Draft Supplement 6 to the 07 series of amendments
Draft Supplement 1 to the 08 series of amendments
to UN Regulation No. 16 (Safety-belts))

**Submitted by the expert from the International Organization of Motor
Vehicle Manufacturers**

Paragraphs 8.4.4.2:

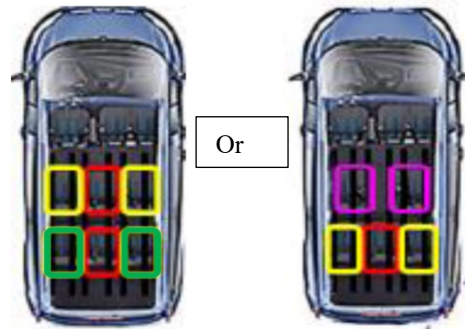
M1 vehicles can have rear seats which can be moved around within the vehicle: they can be installed in different locations within the vehicle as shown in the figure below.

According to the current requirements of § 8.4.4.2, even such seats must allow identification where they are located when the belt is unfastened. OICA therefore proposes that, for such seats, only an indicator would be needed to detect unfastened belts, without actually identifying the exact location of the seat in the vehicle.

- "8.4.4.2. The visual warning shall indicate at least all rear seating positions to allow the driver to identify, while facing forward as seated on the driver seat, any seating position in which the safety-belt is unfastened. For vehicles that have information on the occupancy status of the rear seats, the visual warning does not need to indicate unfastened safety-belts for unoccupied seating positions. **Seats, which can be moved to different positions within the vehicle (e.g. floor rail mounted), shall at least indicate when any rear safety belt is unfastened"**
